CASE SUMMARY SHEET**CASE NUMBER: V23-04-12****DATE RECEIVED: March 6, 2023****DATE OF MEETING: April 11, 2023 and April 25, 2023****Address: 1617 Lakeshore****Subdivision: Old Town of Mandeville, Square 5 Lot 6A****Zoning District: R-1 Single Family Residential****Property Owner: Allison and Brian Froeba****REQUEST: V23-04-12 – Allison and Brian Froeba request a variance to CLURO Section 9.2.5.2. Vegetation Protection Zones, Square 5 Lot 6A, R-1 Single Family Residential District, 1617 Lakeshore Drive****CASE SUMMARY:**

To: Cara Bartholomew
From: Catherine Fuselier
Date: April 11, 2023
Subject: V23-04-12

CASE SUMMARY SHEET

CASE SUMMARY SHEET

SITE PLAN
SCALE: 3/32" = 1'-0"

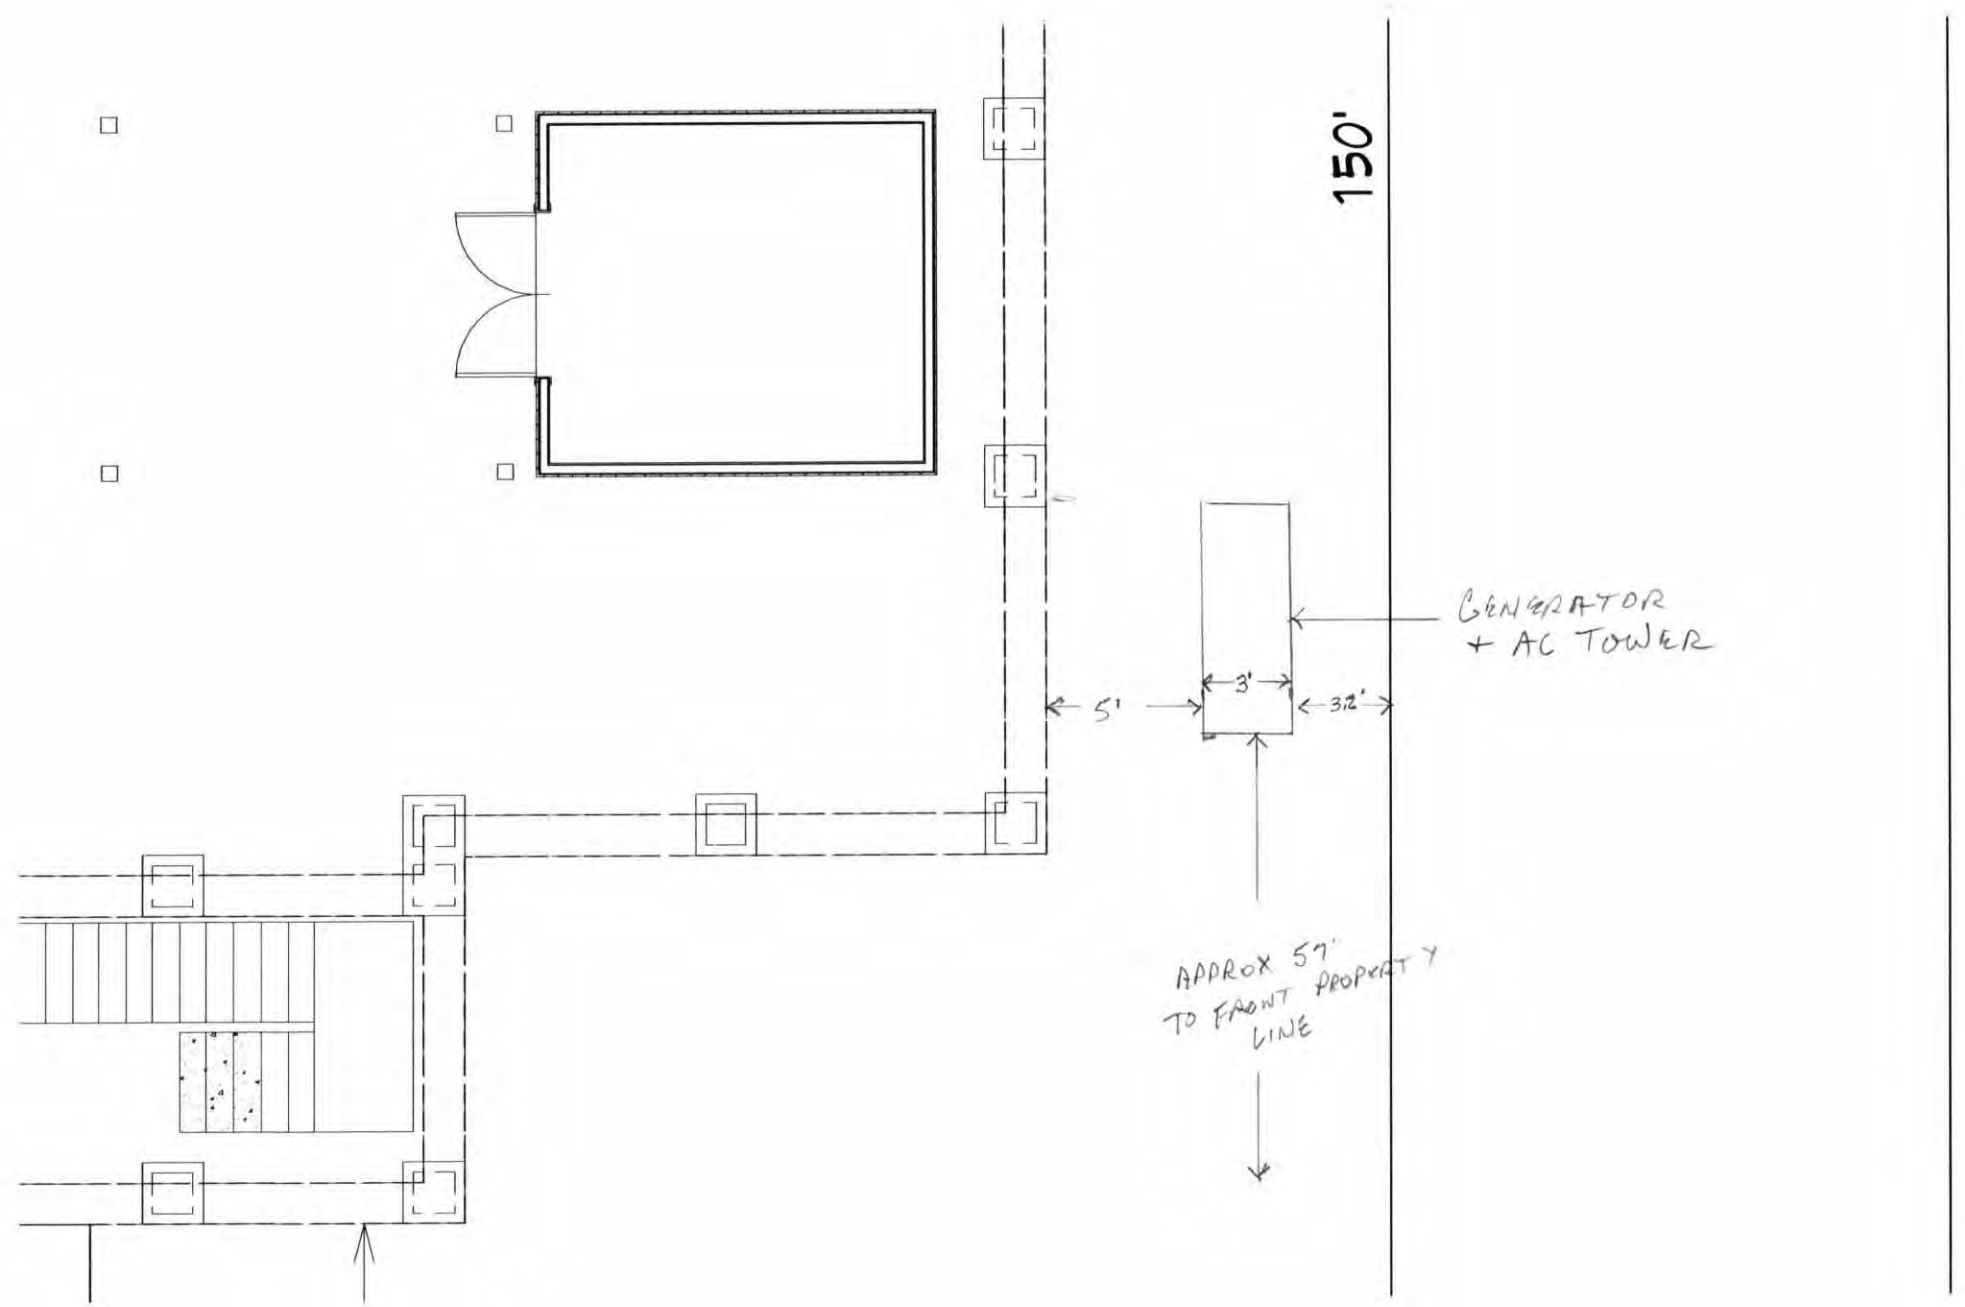
The applicant is requesting an exception to encroach into the west side yard setback to place a generator. The lot has a frontage of 100' requiring side yard setbacks of 16'. The west side setback is currently 11.3' and the east side setback measures 21' due to the allowed 30% flex. The proposed location of the generator would encroach 8' into the west side setback, leaving a remaining setback of 3.2'

We are requesting a Variance/Exception on the new build at 2816 South Street regarding the placement/location of the AC units and generator. We want to locate them on the western side of the house. The distance between the side of the house and property line is only 11 feet 3 inches. We need a variance or exception that would allow us to place the platform and units closer to the property line.

1 SITE PLAN
1/8" = 1'-0"

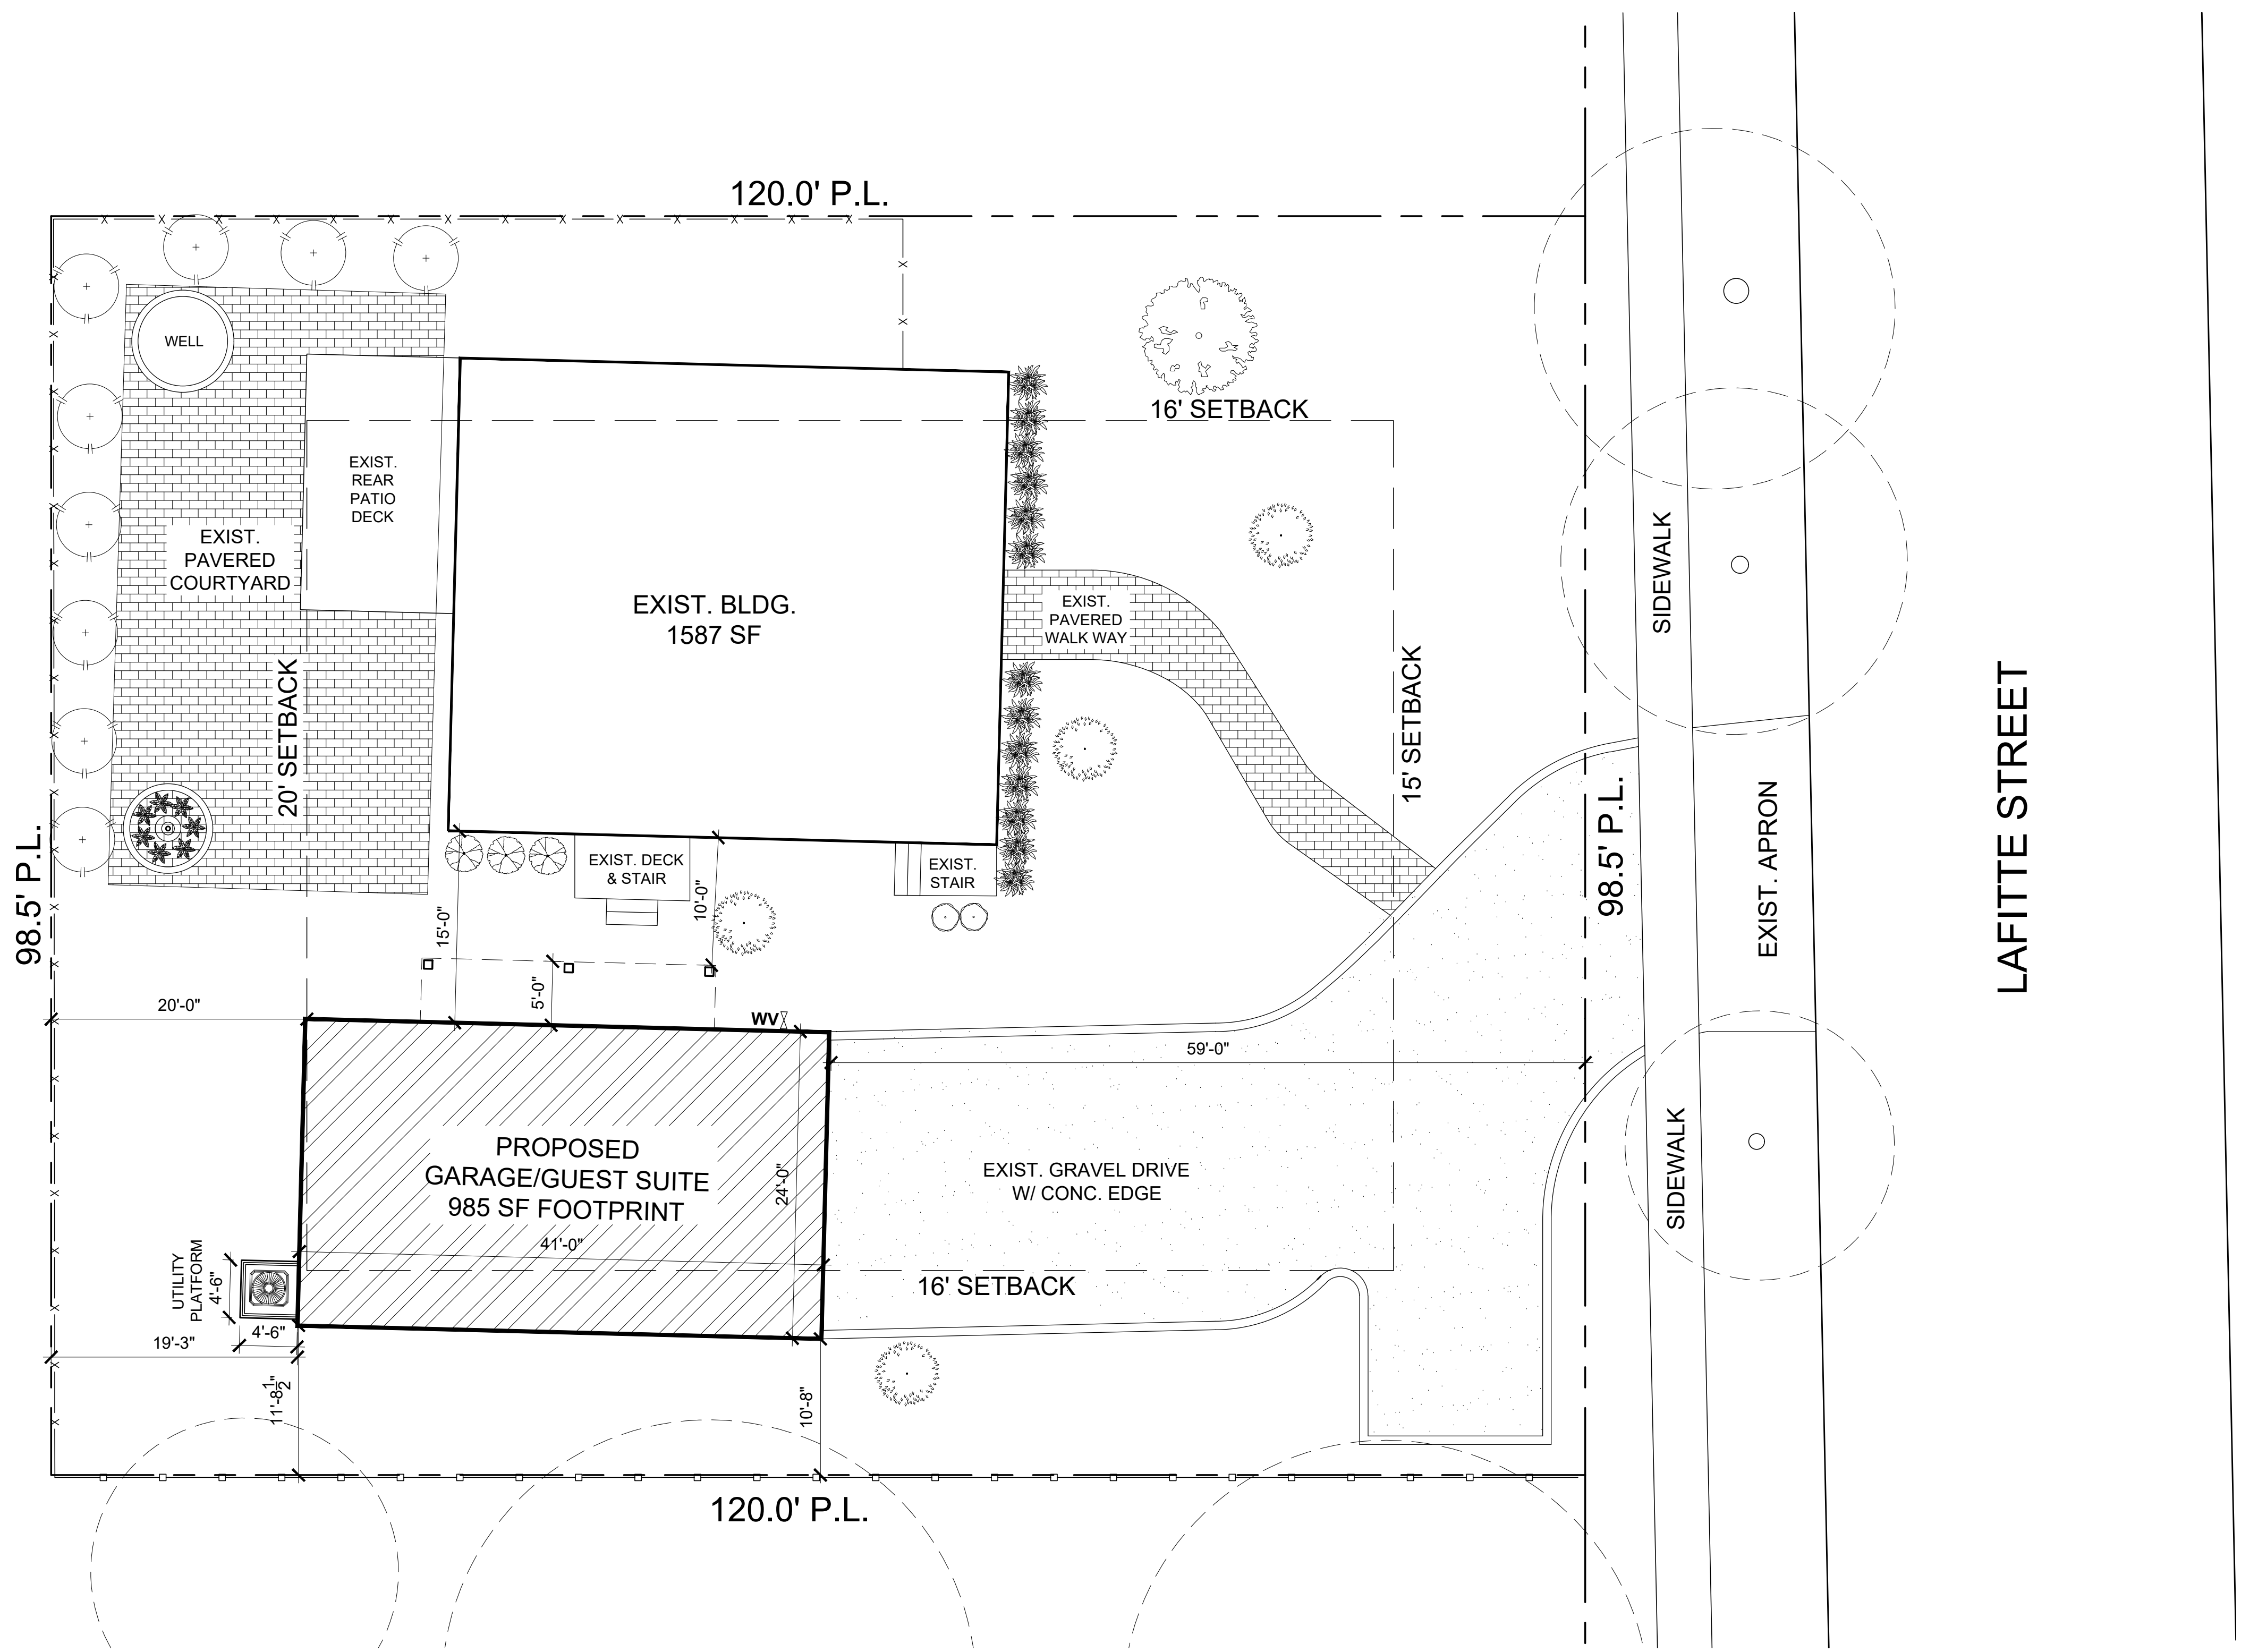
The applicant is requesting to construct a two-story garage and guest suite being 985 sqft. The B-3 District allowed for an accessory dwelling unit. The proposed structure is in accordance with Section 8.1.14 Supplemental Regulations for Accessory Dwelling Units. Should the building be converted into Commercial uses the State Fire Marshall requires a 10’ setback between buildings. To maintain the required 10’ of space between the two buildings, the guest suite will encroach into the south setback by 5’-4”.

The lot has a frontage of 98’ requiring 16’ side setbacks. In an updated site plan submitted by KVS architecture on April 19th the proposed garage and guest suite would encroach into the setback by 5’-4” leaving a setback distance of 10’-8”. The building can not utilize the flex due to the existing buildings encroachment into the setback. The accessory structure would be compliant with the flexibility.

SITE PLAN - FENCE

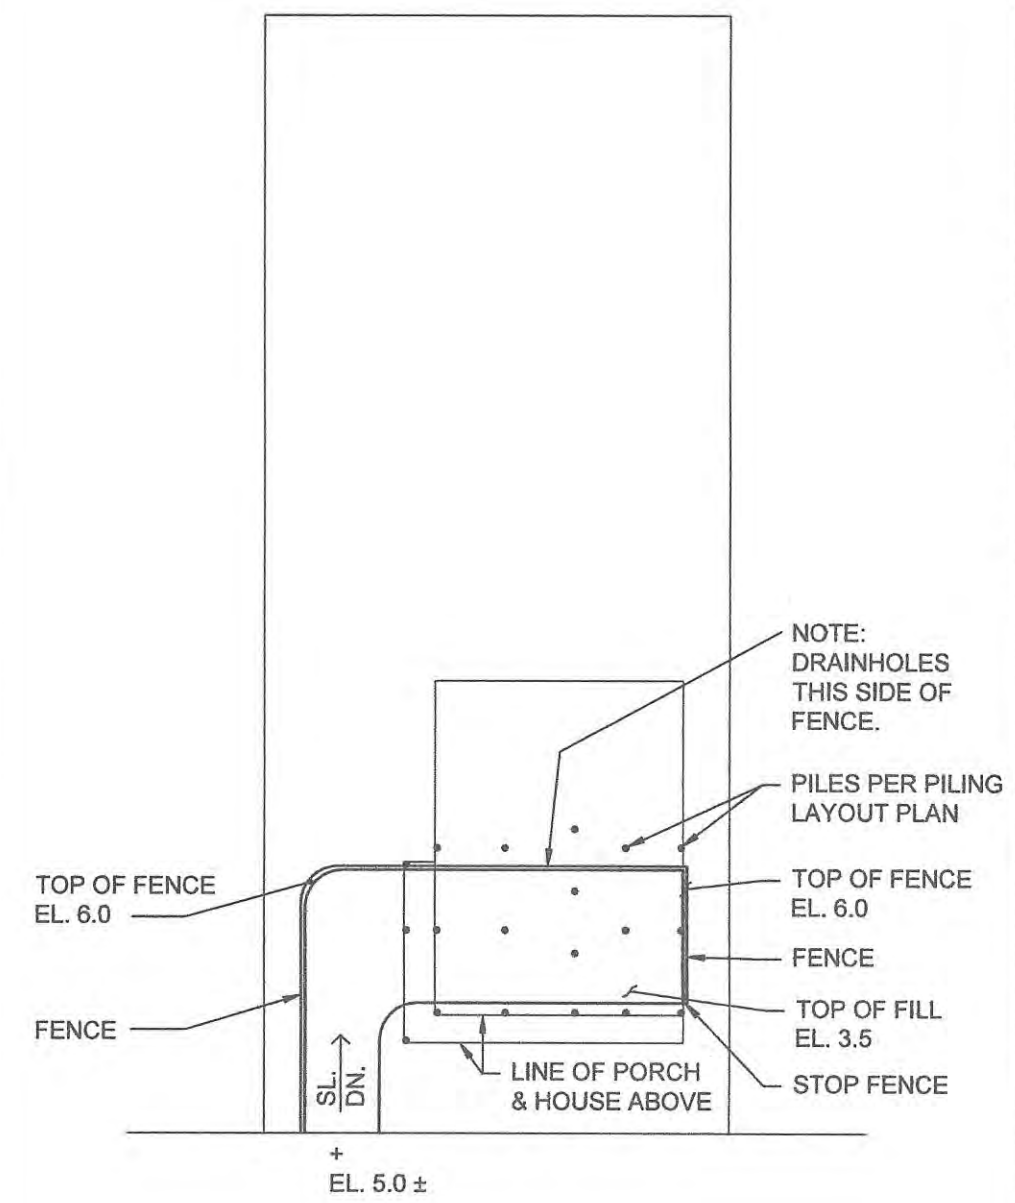
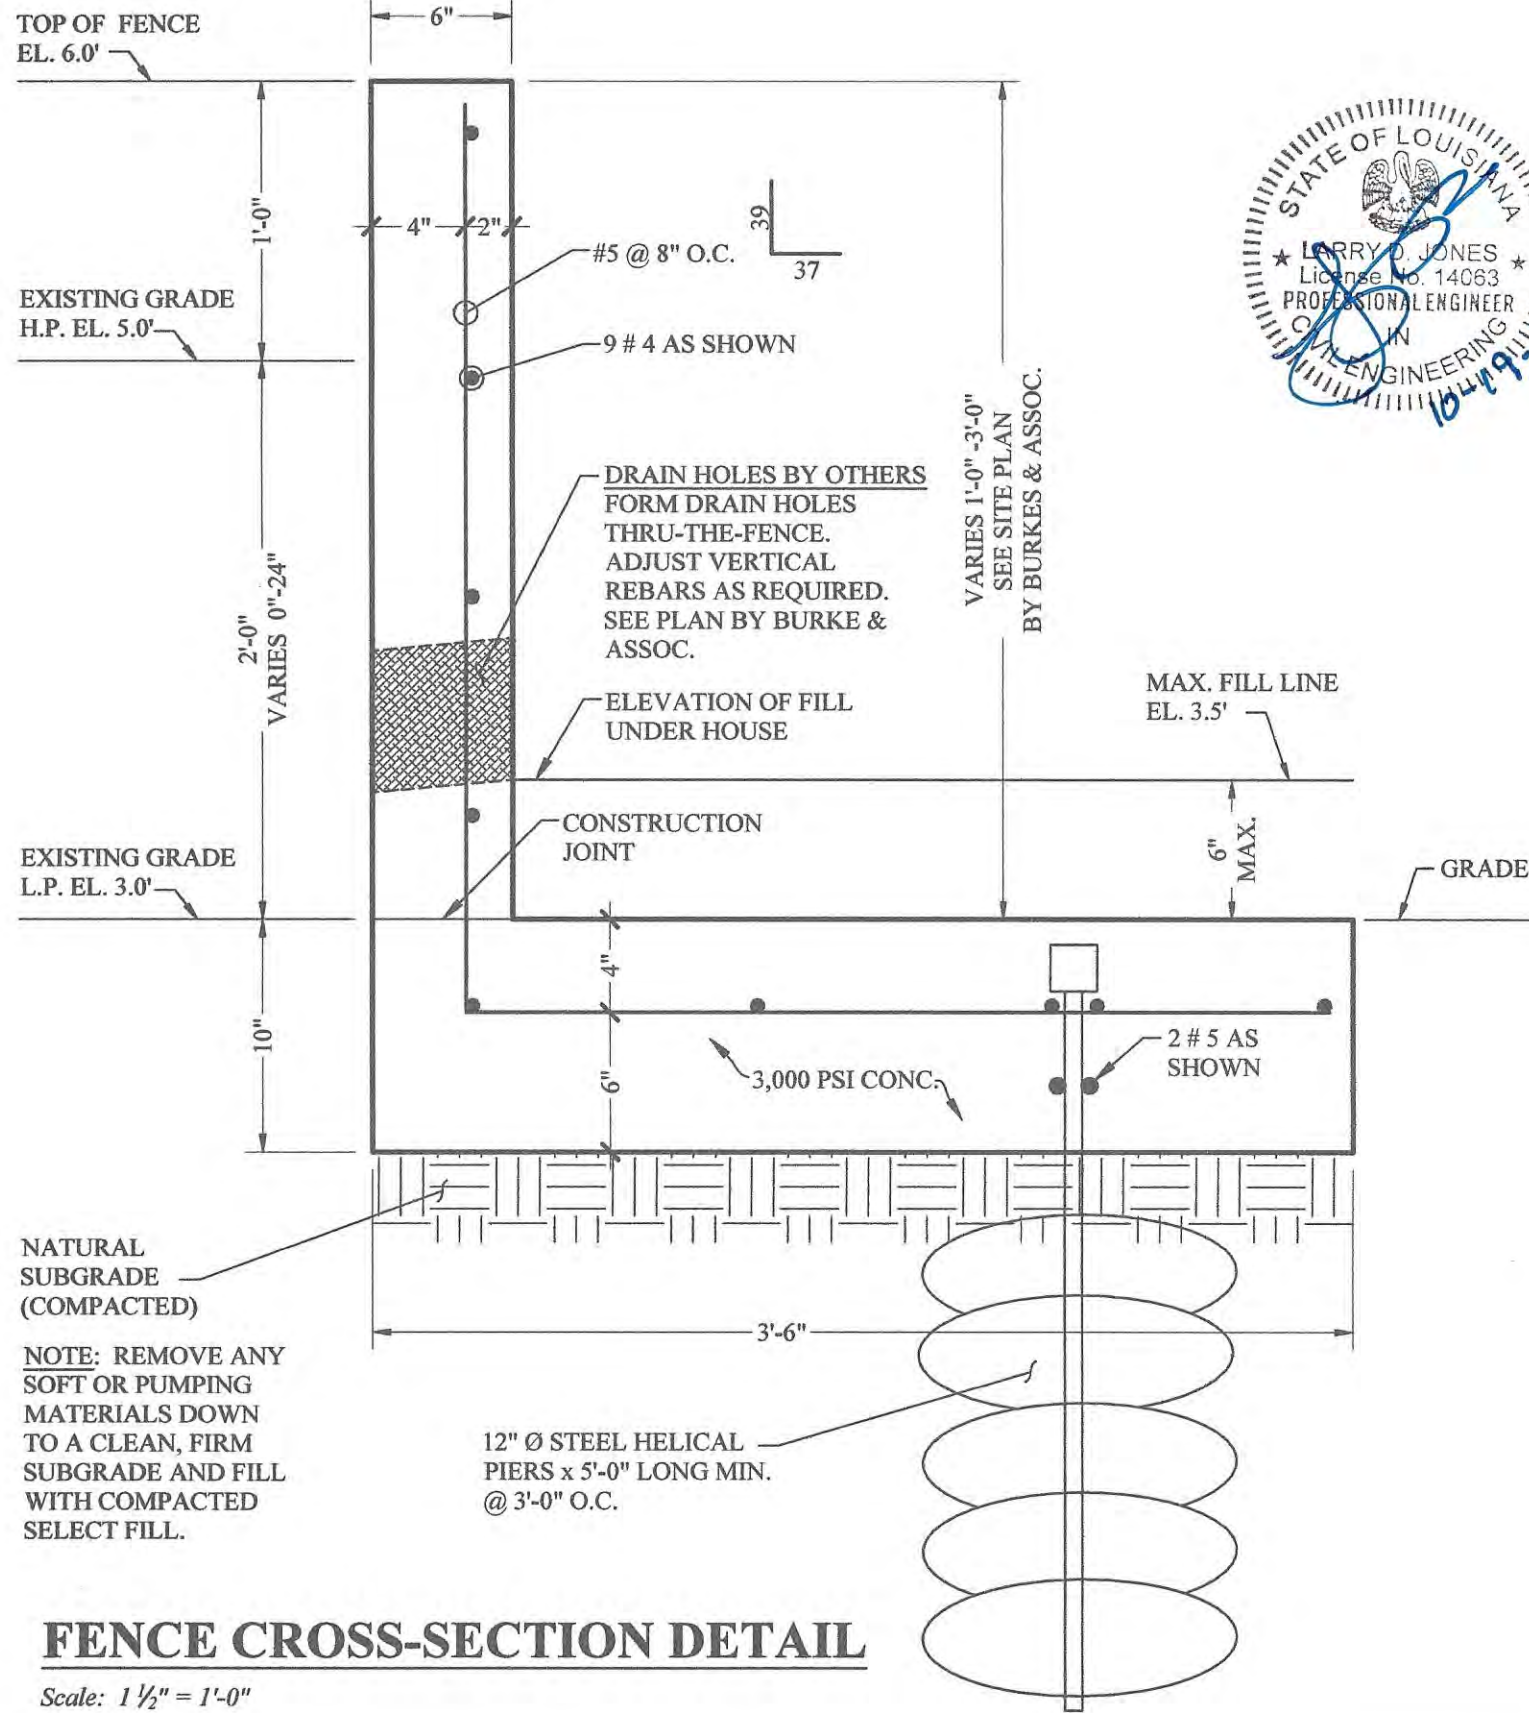
A retaining wall is being proposed along the rear edge of the area to be filled. This is to prevent any fill from running off from the placement area. The wall will run along the outer edge of the driveway, across the rear boundary of the fill area, and along the eastern side of the proposed fill area before ending. The top of the wall will have an elevation of 6' and the wall will have drainage outlets on the rear (north) side.

In addition to the foregoing, my client is also proposing to install a retaining structure along the limits of the fill, all as set forth on the plan by H & H Engineering, Inc., which is also attached hereto. As you will see, this barrier will extend along the boundaries of the additional fill material, and the driveway for the residence, to assure that the fill does not sluff off and/or migrate from the point of placement.
